AFFIDAVIT OF REMAINING MONUMENTATION

I, Paul D. Galli, being first duly sworn, depose and say that in accordance with O.R.S. 92.070(3)(b), I have correctly surveyed and marked with proper monuments the remaining lot corners as indicated on the plat of Rivercrest Estates 2, Phase 2 (Volume 22, Page 56), instrument number 2007-019725, as recorded in Plat Records of Douglas County. Said interior corners were set on March 21, 2008.

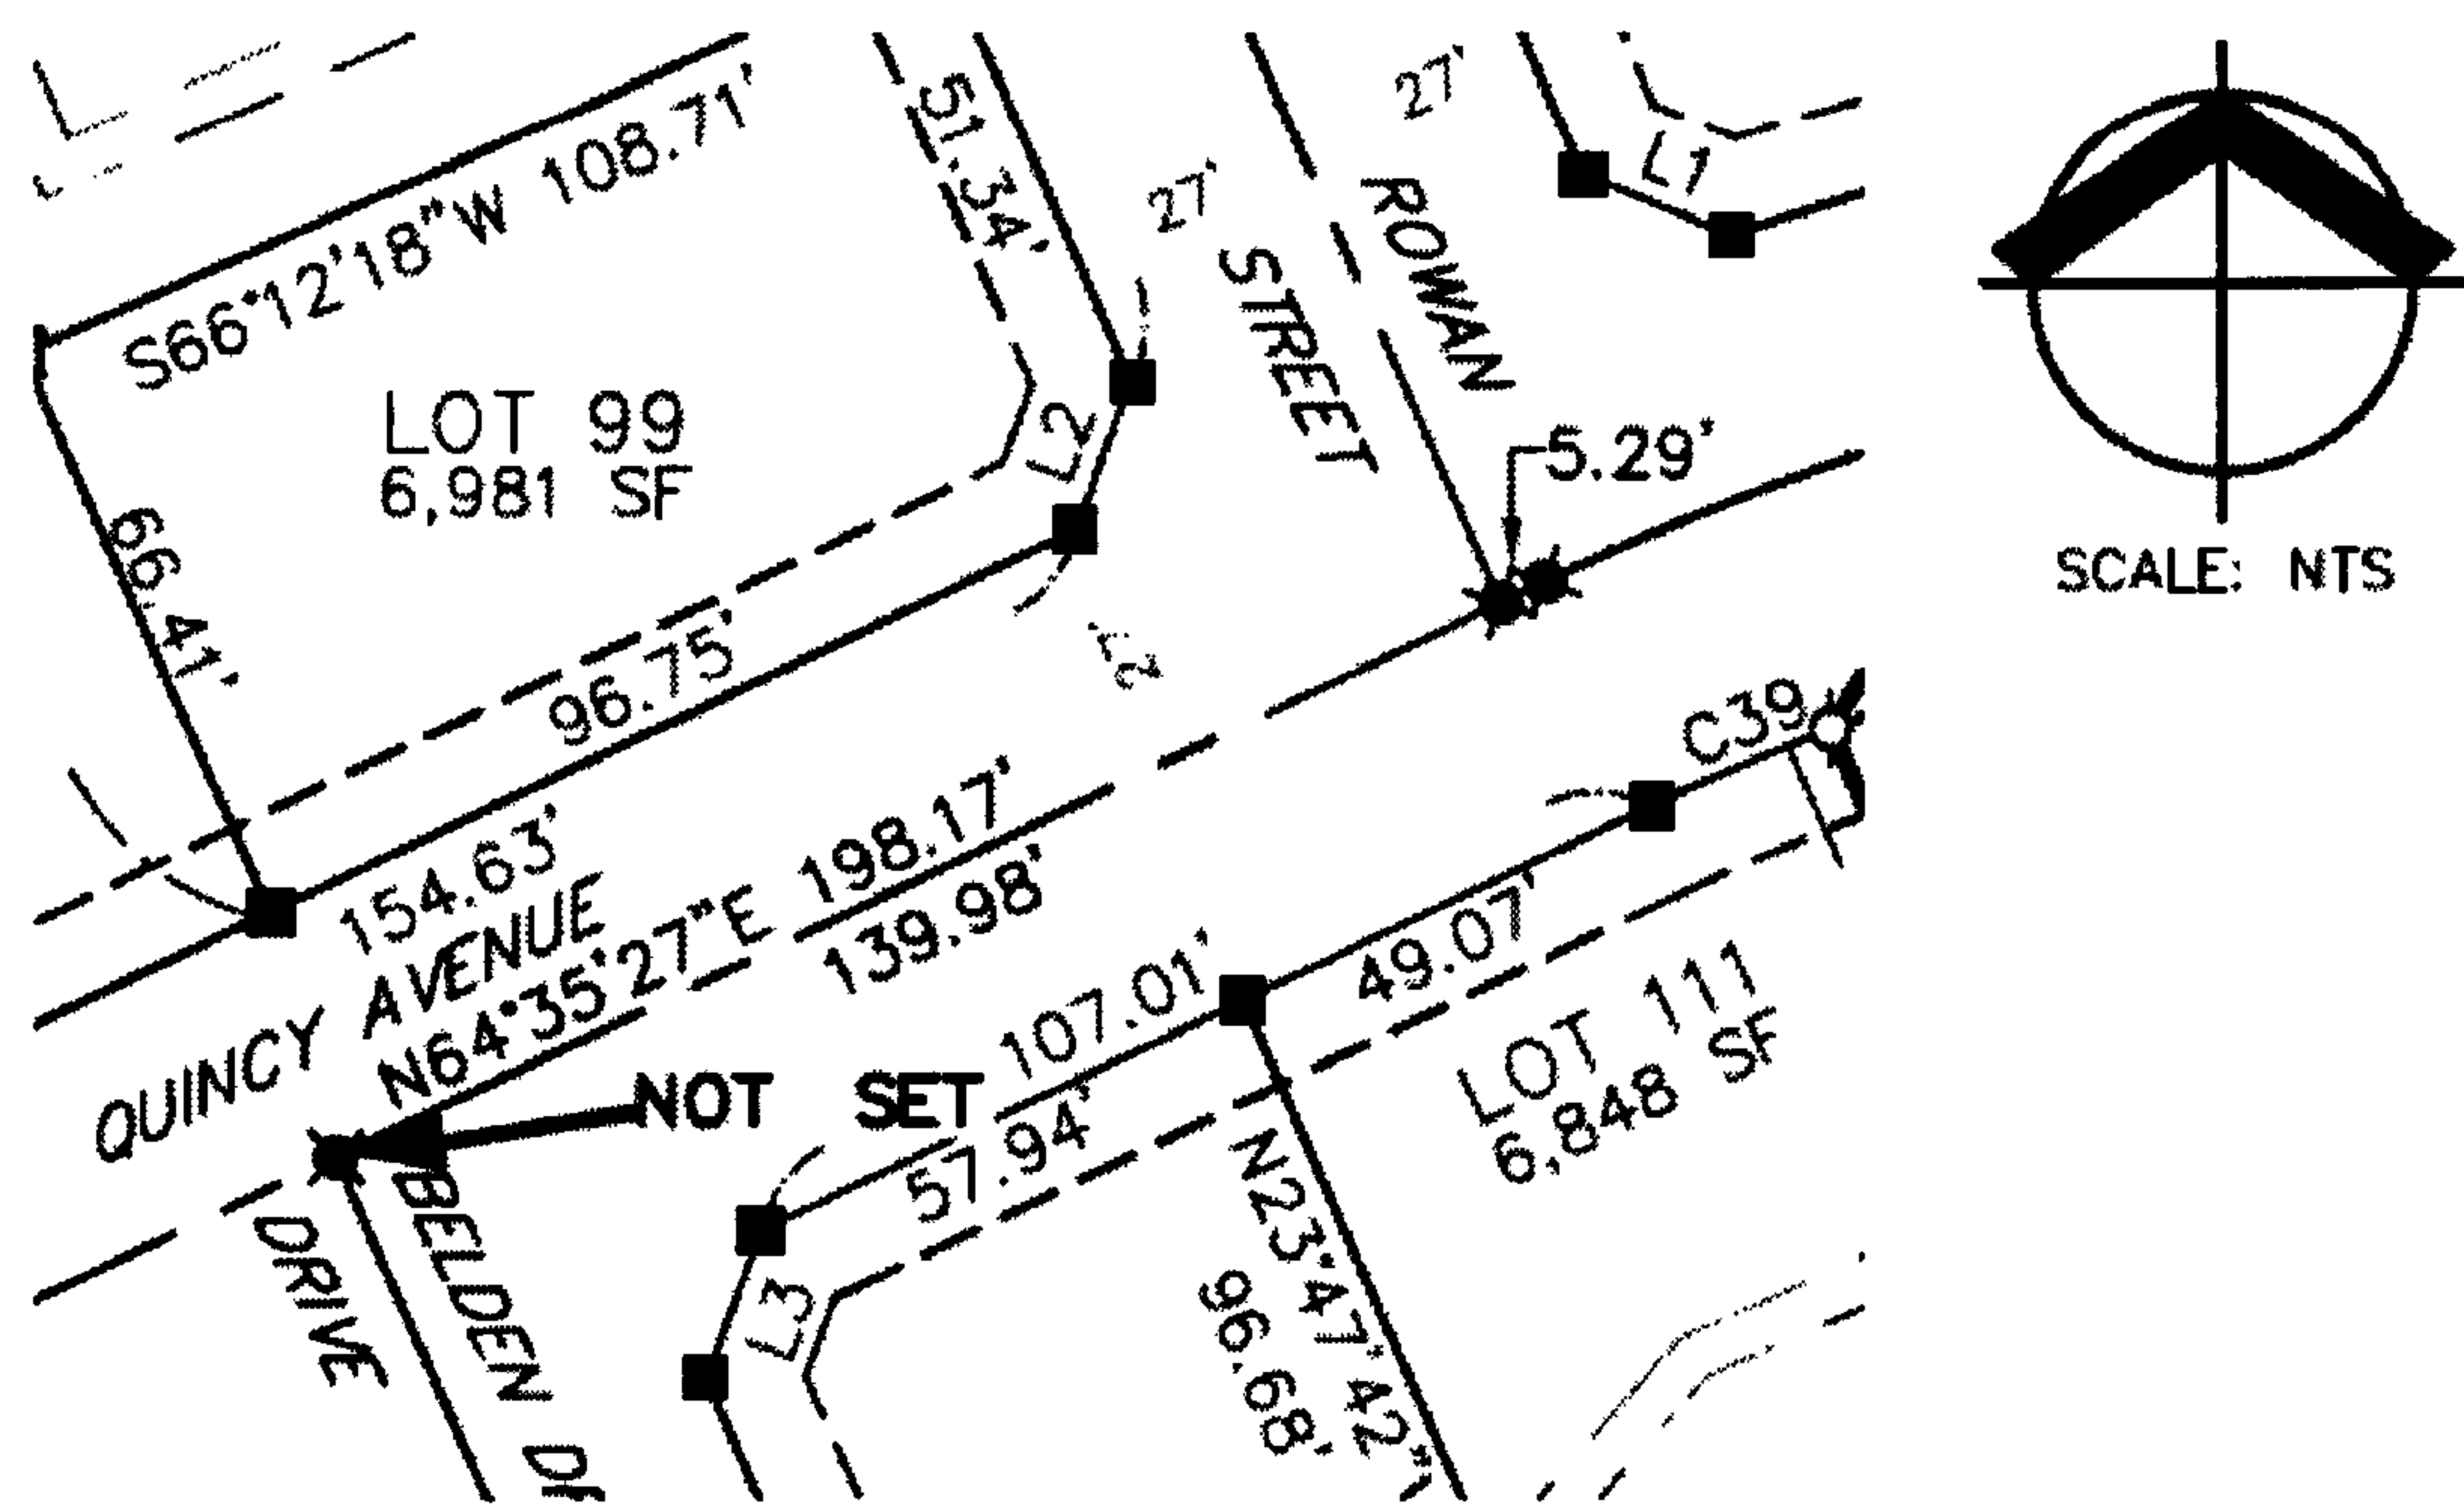
- 3) At the intersection of the centerline of Quincy Avenue with the centerline of Rowan Street, a centerline monument was **NOT** set due to conflict with a sanitary sewer manhole.

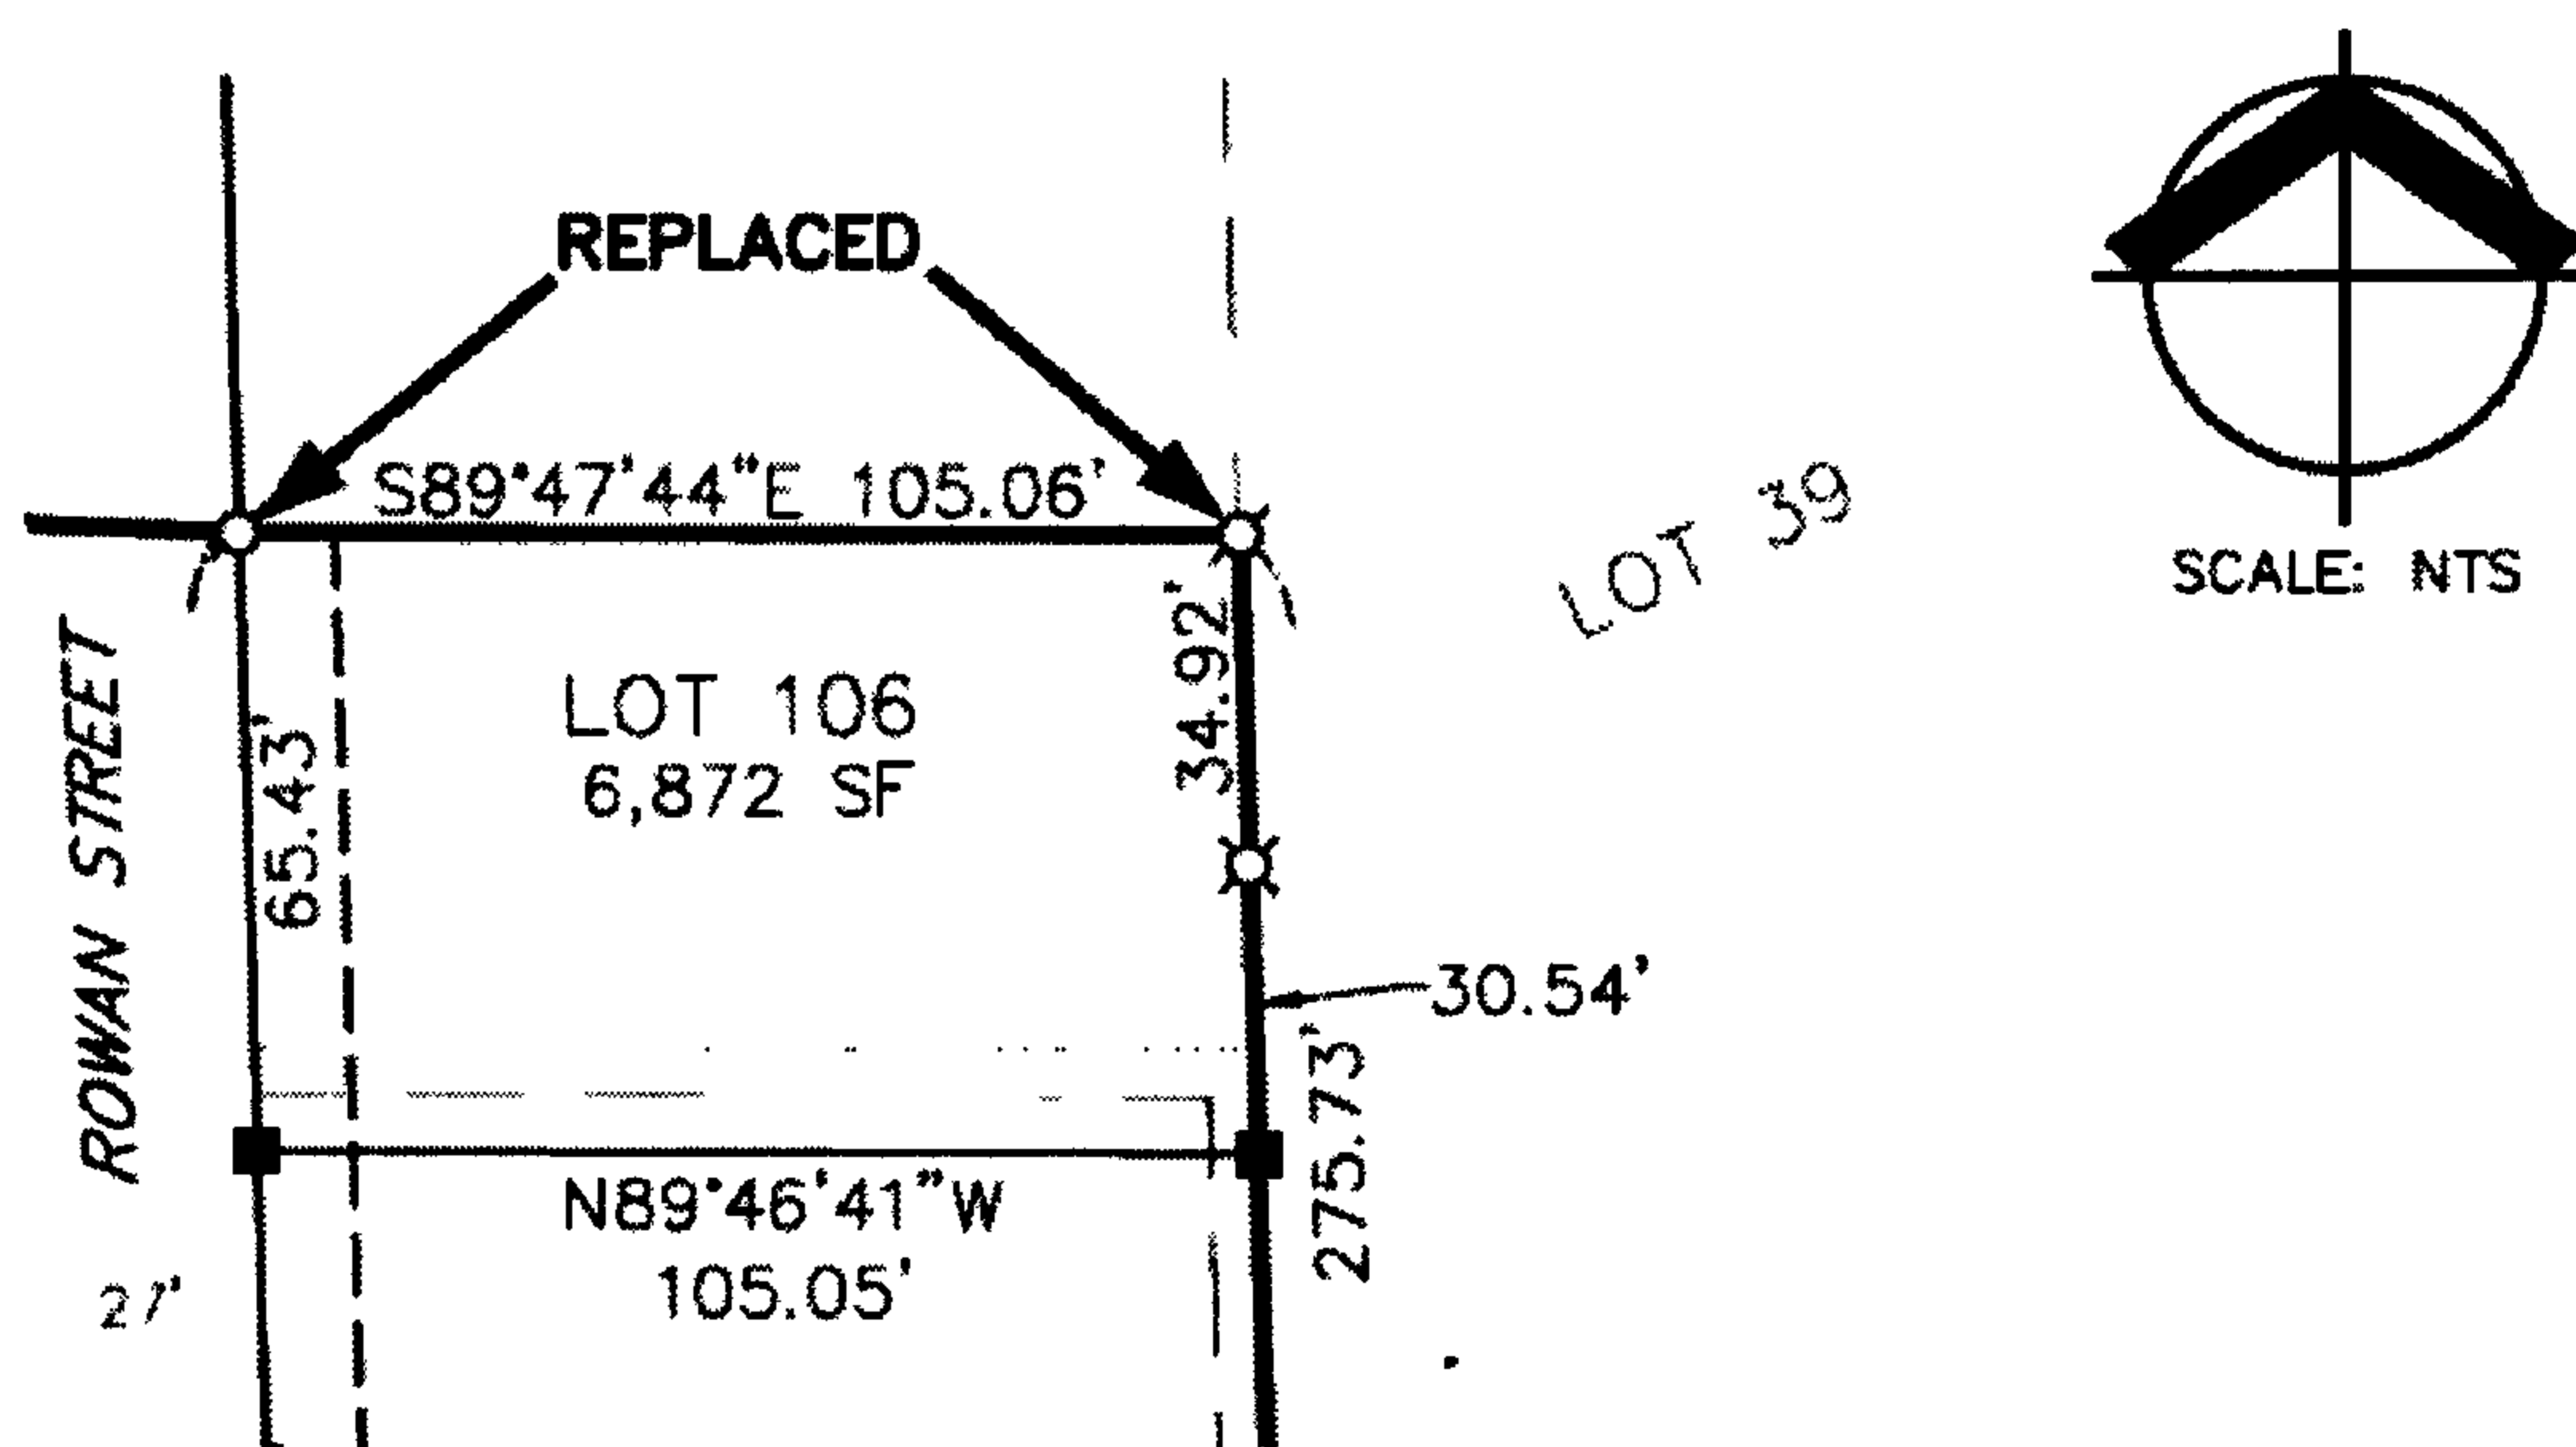
4) At the intersection of the centerline of Quincy Avenue with the centerline of Belden Drive, a centerline monument was **NOT** set due to conflict with a sanitary sewer manhole.

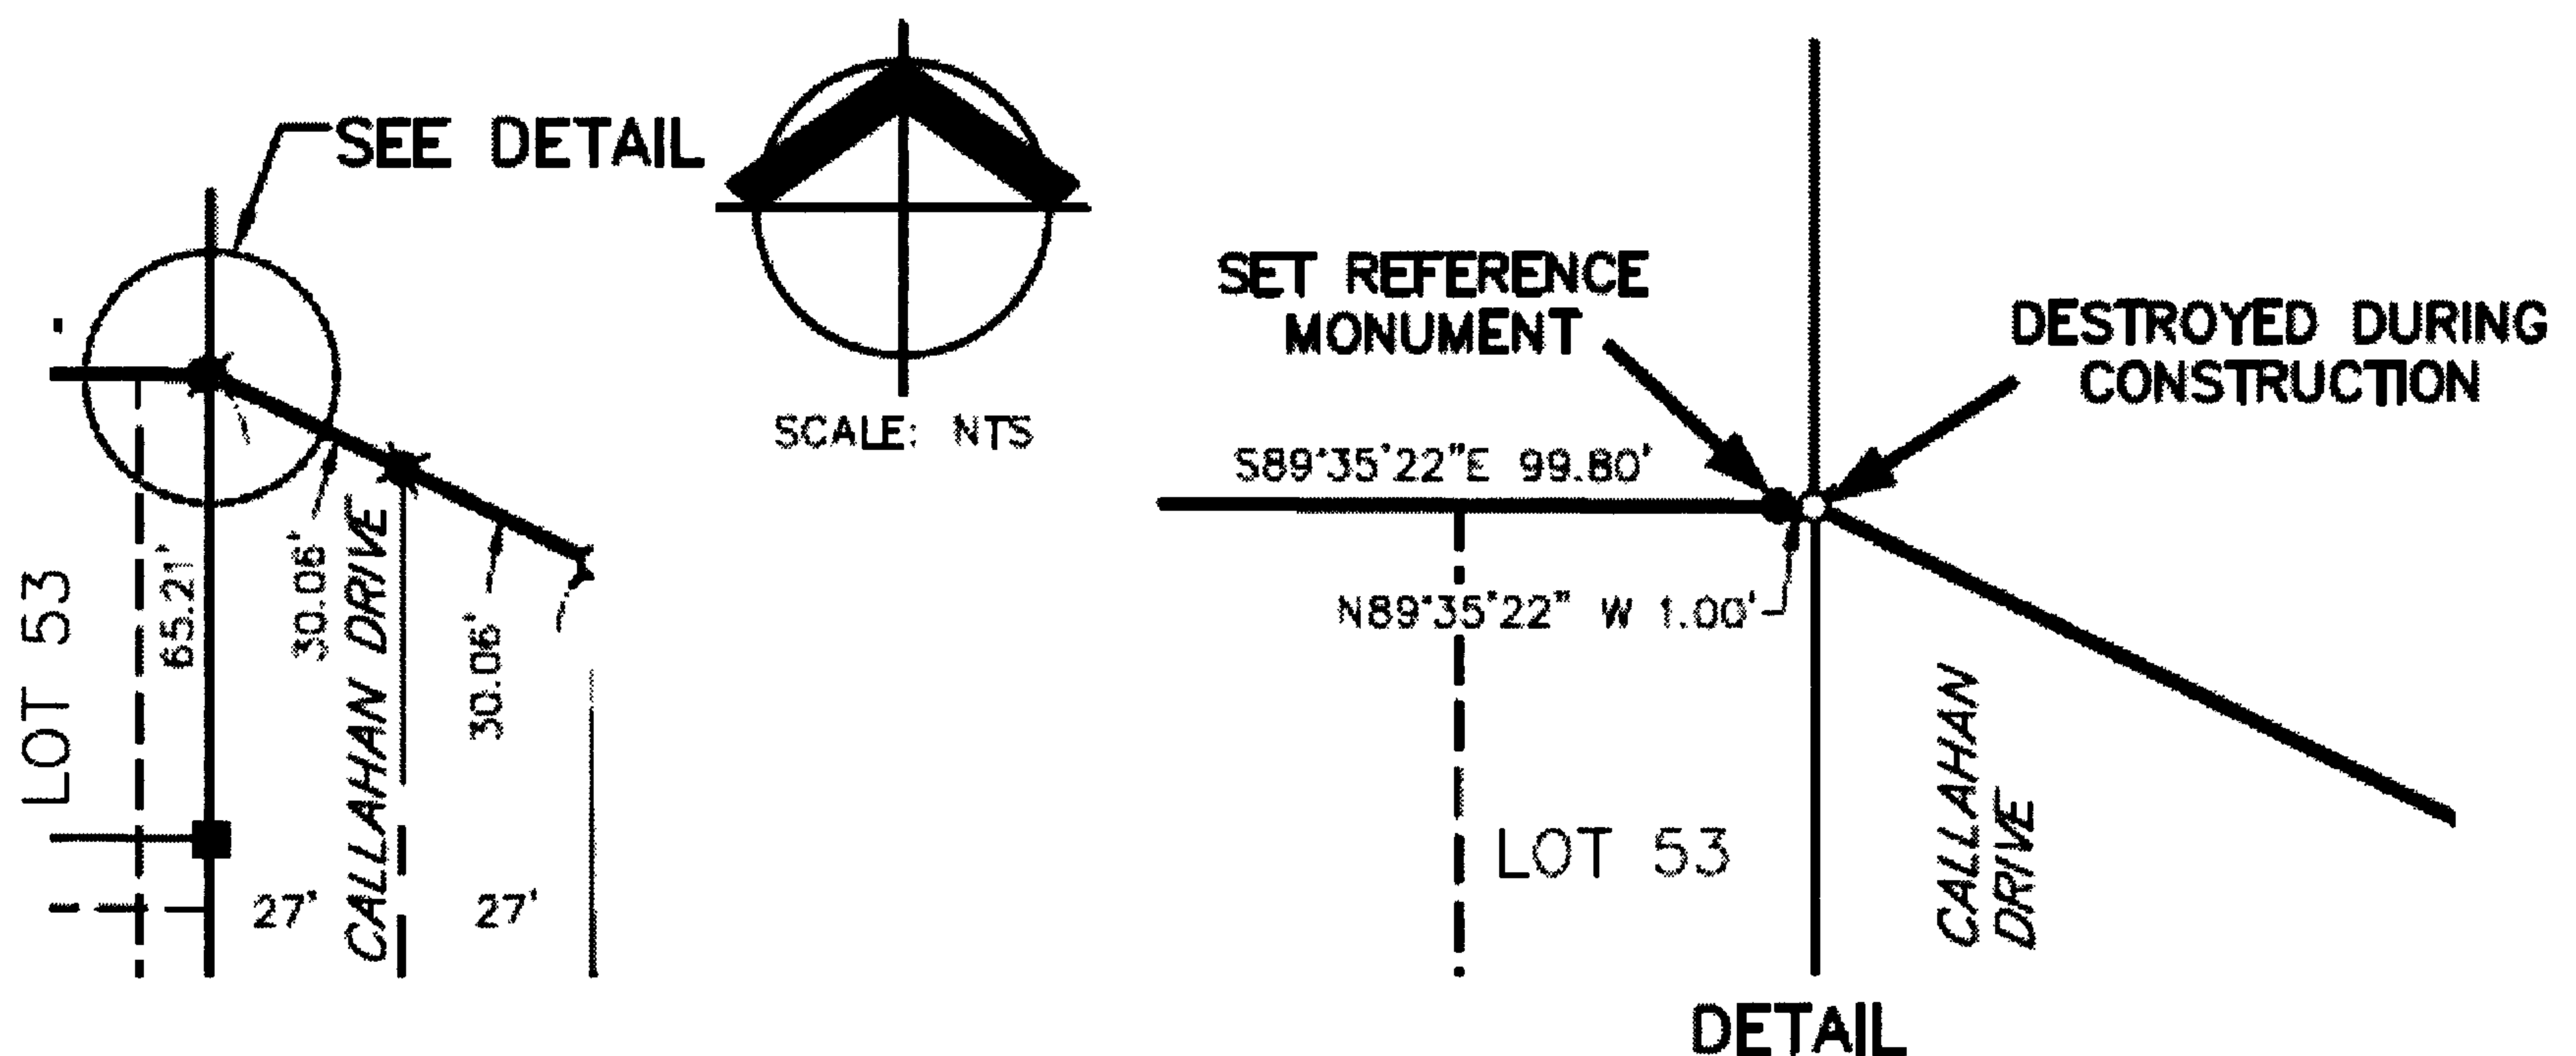
5) At the northwest and northeast corners of lot 106 the two 5/8" iron rods with yellow plastic caps marked "I.E. ENGINEERING" were destroyed during construction and replaced with 5/8" by 30" iron rods with yellow plastic caps marked "WRG DESIGN INC." in the original locations.
